CITY OF WESTMINSTER
Special Mayor and Common Council Meeting
Wednesday, June 3, 2020 at 2 pm
https://www.facebook.com/westminstermd/

Re: Approval – Warner Construction Contract Change Order Nos. 5, 6, and 7

Re: City of Westminster Administrative Office Building Renovations & Alterations
Project no. 20-02

Change Order #5- Corrections and Alterations to Unforeseen Framing Conditions

OPTION - A

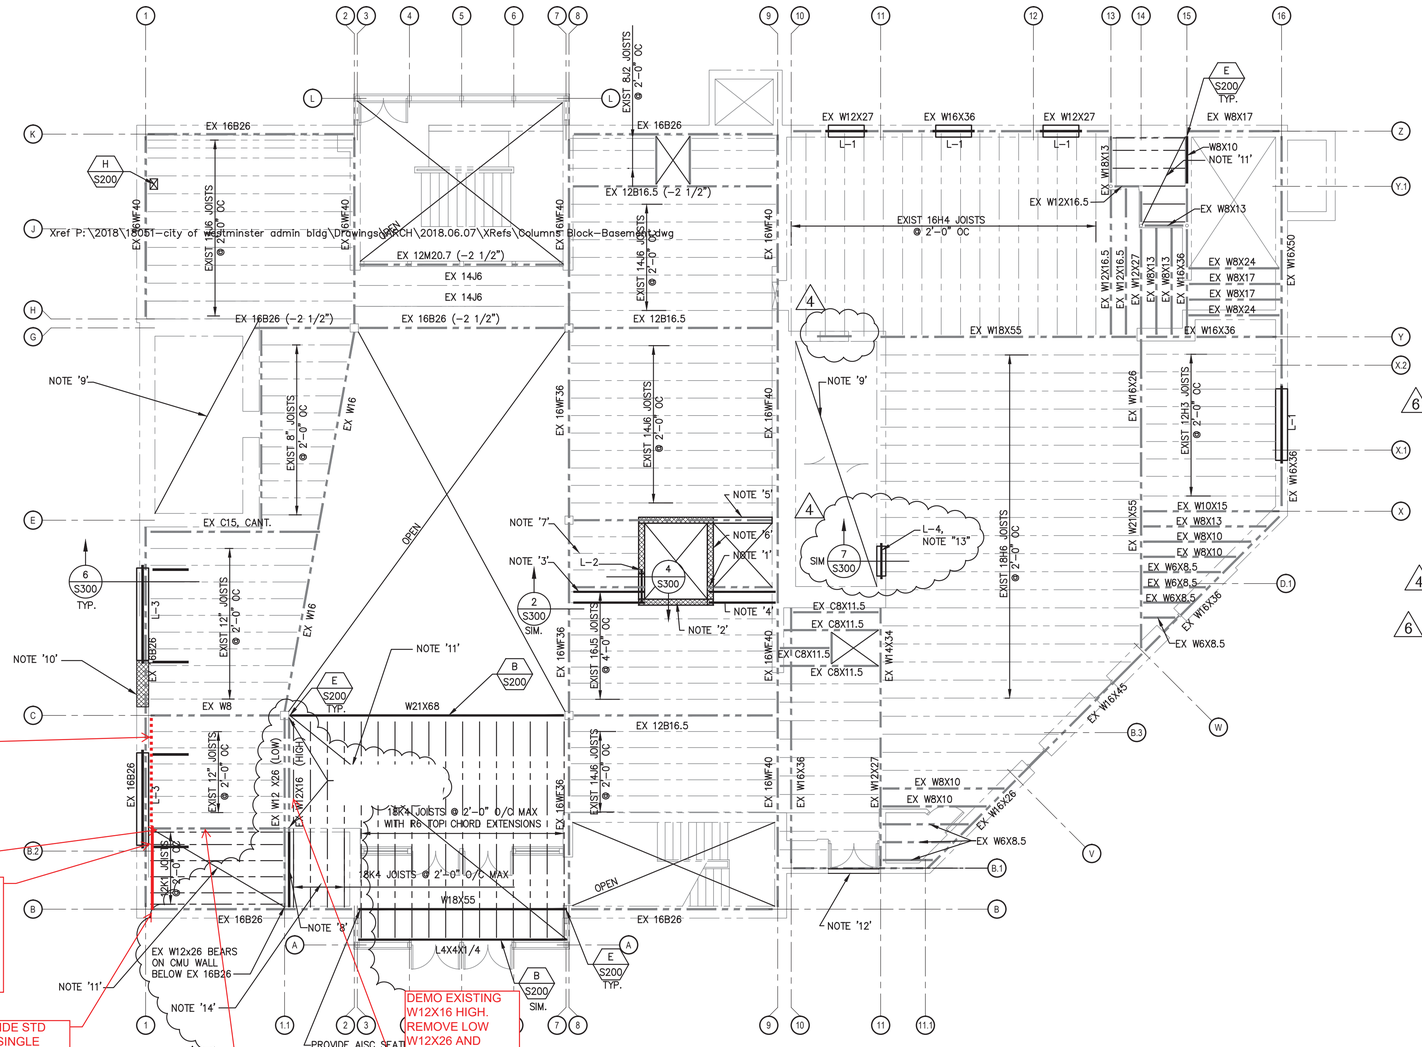
Question:
Can you look over these 2 changes that my steel subcontractor picked up:

1.See attached SK235A – the 6 pieces of J4 joists were ordered 3 ½" too short see sketch for possible solution.

2. See CL 1.1-C – existing column only has a 6 1/2" wide flange. The connection angles and web thickness of the W21X68 beam are 7 11/16" wide. Can we utilize a seat angle and roll clip here as we are at the beam on line B.

- Materials and labor to shore the bay from 1 to 1.2 and B to C.
    - Detach joists on 1.2 line.
    - Remove two (2) beams just above line B.2, allows window installation.
- Add new beam with moment splice on line 1, this eliminates the problem of the short joists.
- Remove upper beam on line 1.1, relocate and refabricate lower beam at joist bearing elevation.
- Re-attach joists to relocated beam.
- Remove shoring
- Daily and final clean up

1. Contractor to provide pricing for the (2) solutions described on attached sheets S102 – Options A & B. Pricing to be reviewed by Owner to determine which solution to be executed; final direction to be given following price review. Both options will resolve issue of the joists being too short.
2. A STD AISC Seated connection with stability angle (roll clip) is acceptable.

D101

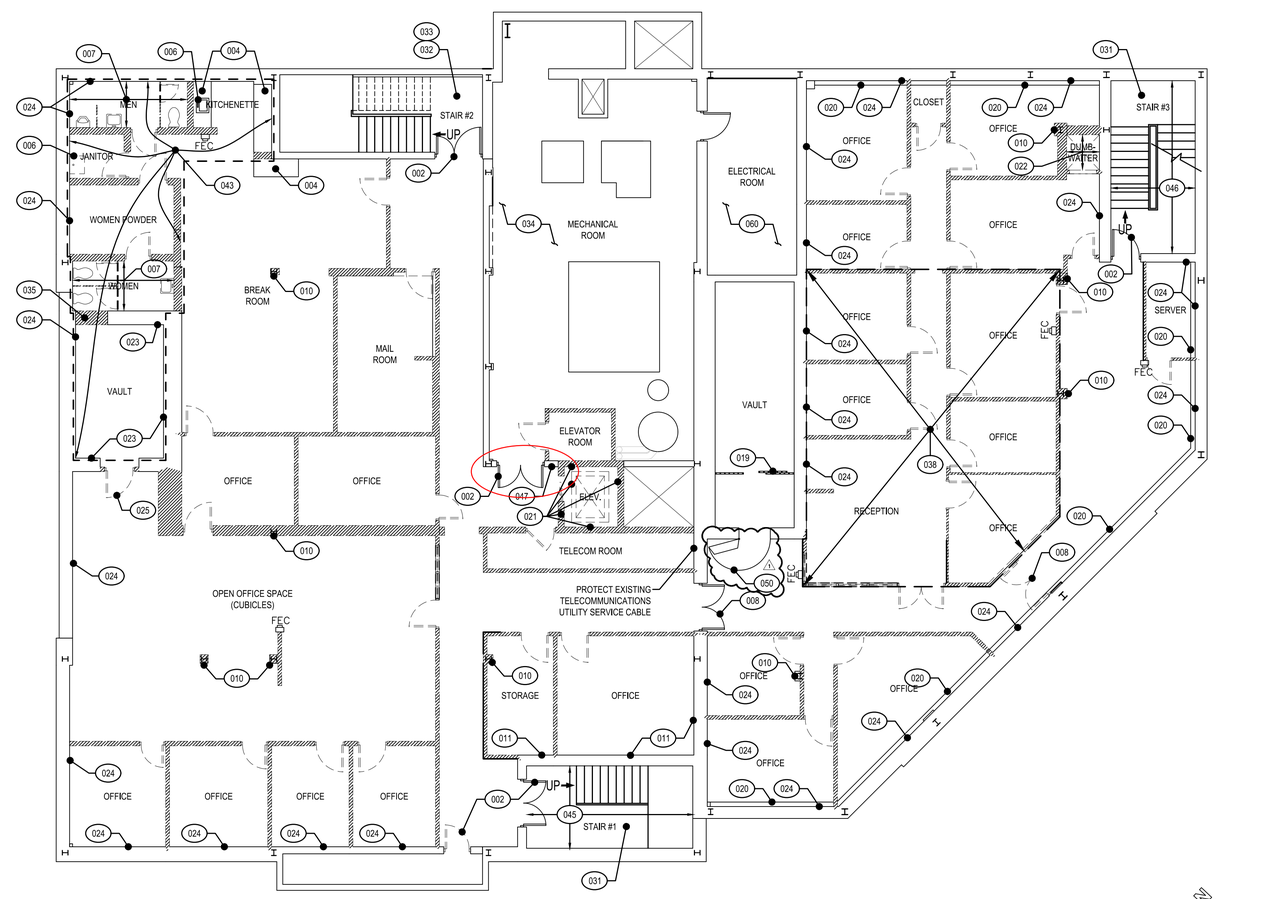
Tear out block wall for safe demo and safe conditons for concrete and proper construction on new walls and elevator pit (Design Issue)
Tear out door frame and door
Demo Footing not shown shown on S100 to accomadate new pit construction

Provide new frame for opening 008 in 8" CMU.

S100

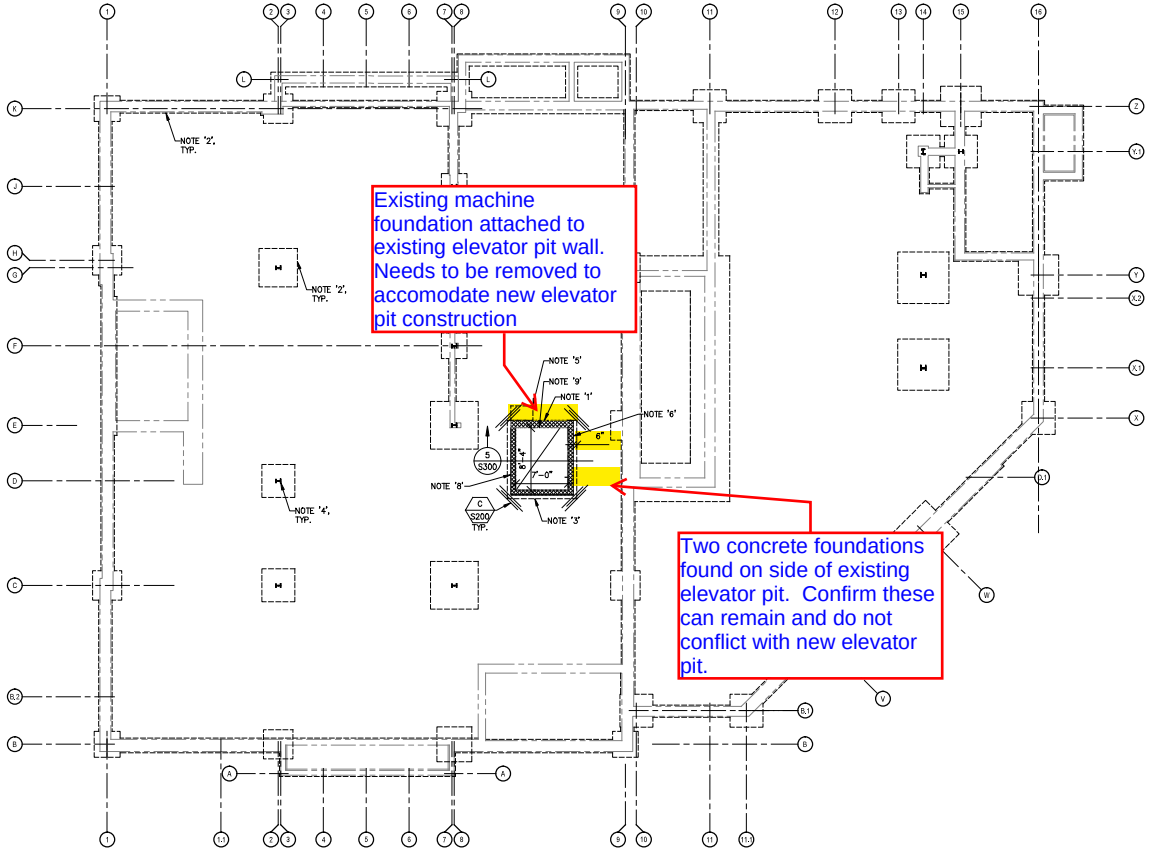
The scope of work involved in this modification is necessary to allow for construction of the new elevator pit and hoistway. During demolition, several large concrete footings were uncovered that were not shown on the as-built drawings from previous renovations and had to be removed to clear the way for the new elevator pit foundation. Also included in this price is work to remove and rebuild a CMU block wall that was scheduled to be remain, but once the additional footings were discovered, this wall needed to be undermined to fully demolish the unforeseen concrete masses; thus, requiring this scheduled to remain wall to be demolished.

SHEET TITLE:
RFP - 7 : MASONRY INFILLS

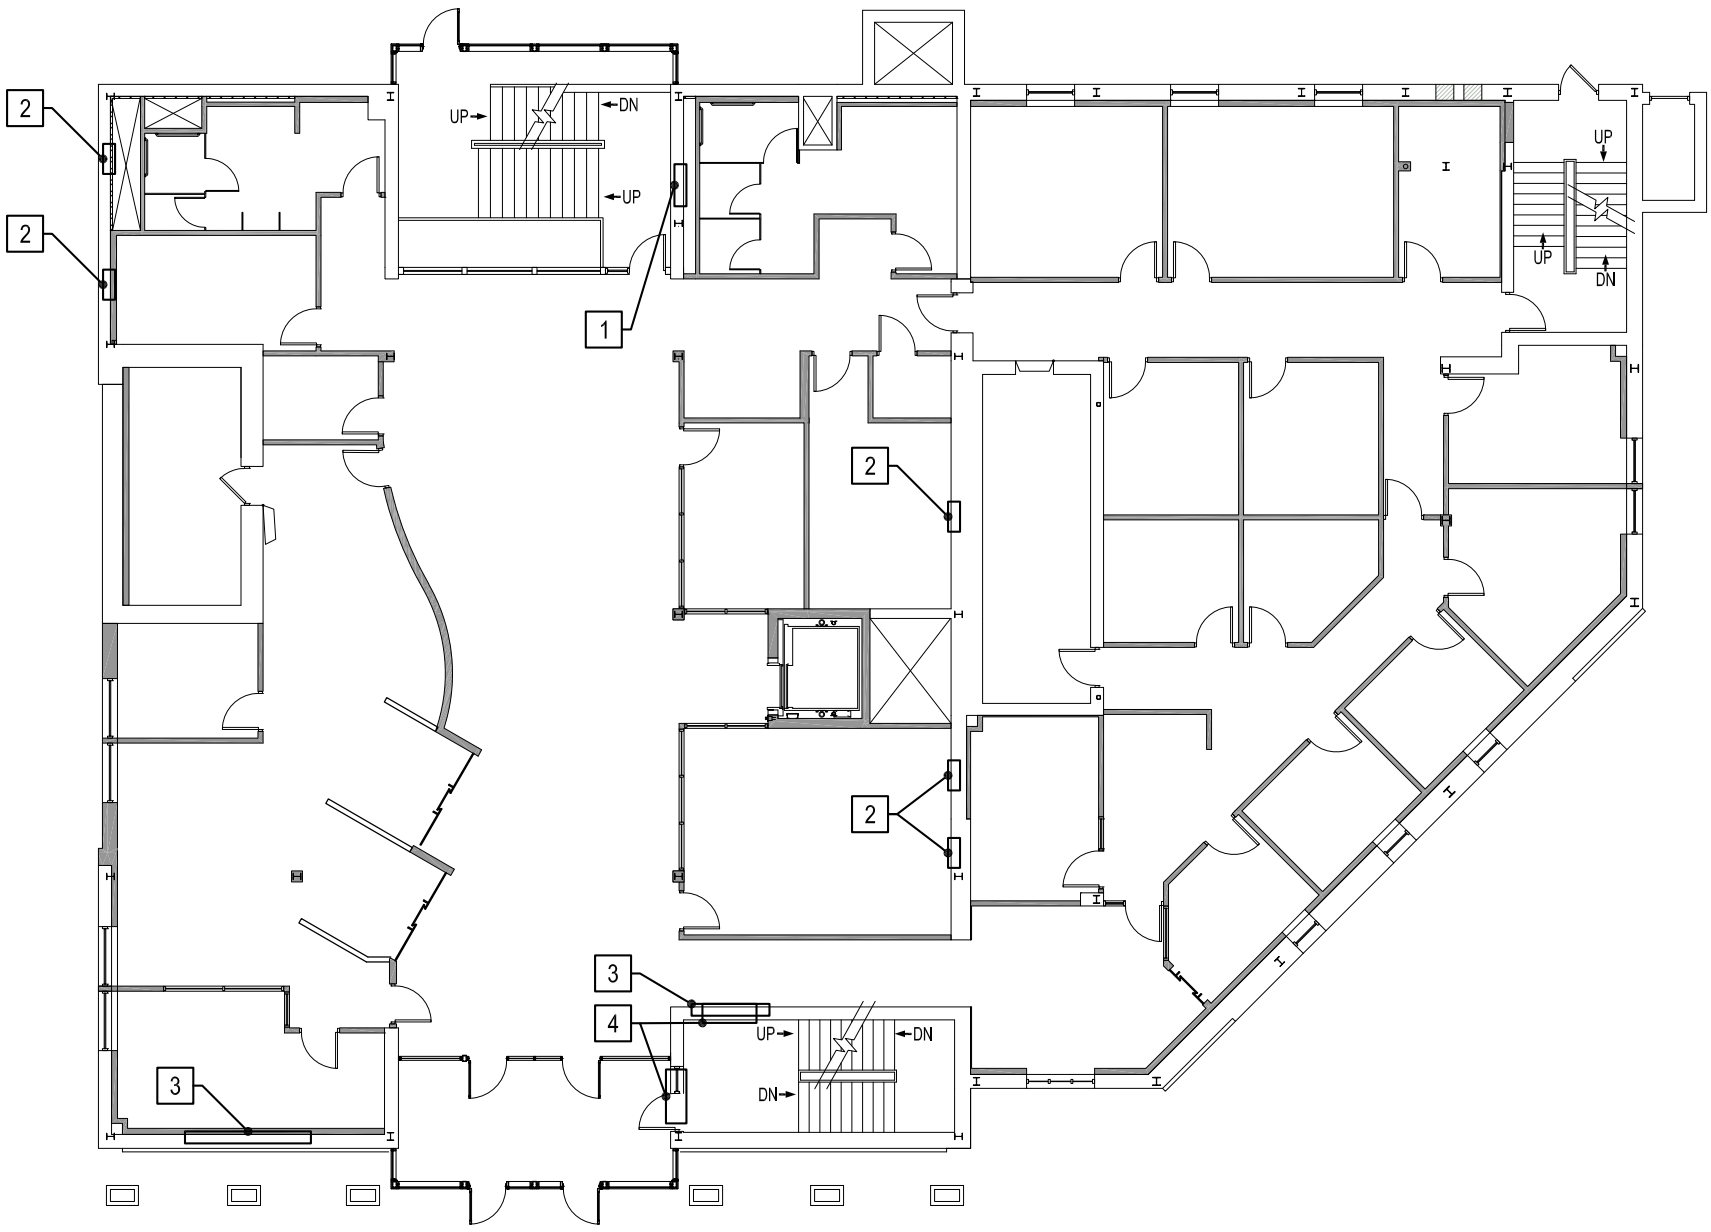
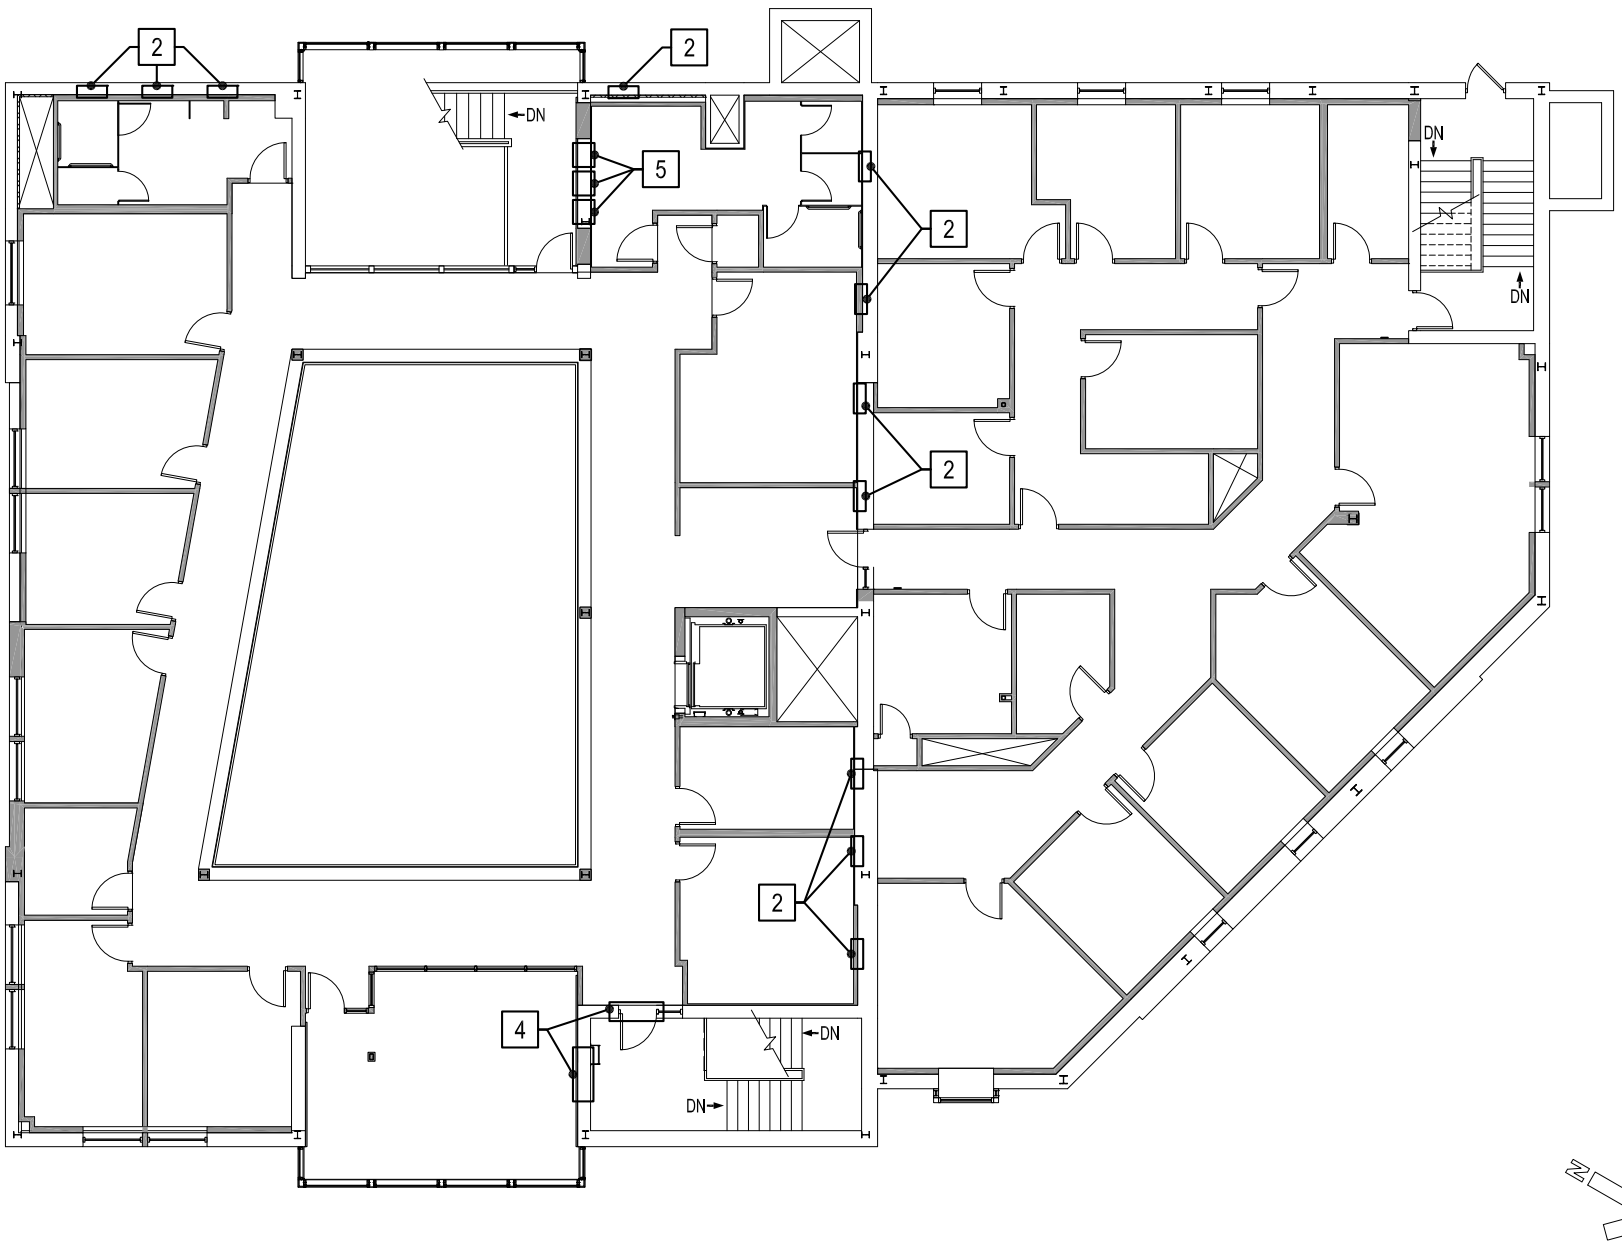
The scope of work involved in this modification is necessary to ensure that all abandoned floor deck and rated stair penetrations are sealed and structurally sound following the demolition of the existing HVAC system. The previous system utilized cavities in the exterior CMU block walls to supply and return air. These cavities have since been abandoned with the new HVAC system, and need to be infilled to ensure proper fire/smoke separation between floors and stairways, as well as to eliminate these cavities as possible weak points in the wall.

Contractor shall also provide a unit price for each of the above infill types in the event that additional penetrations are discovered that require infill.
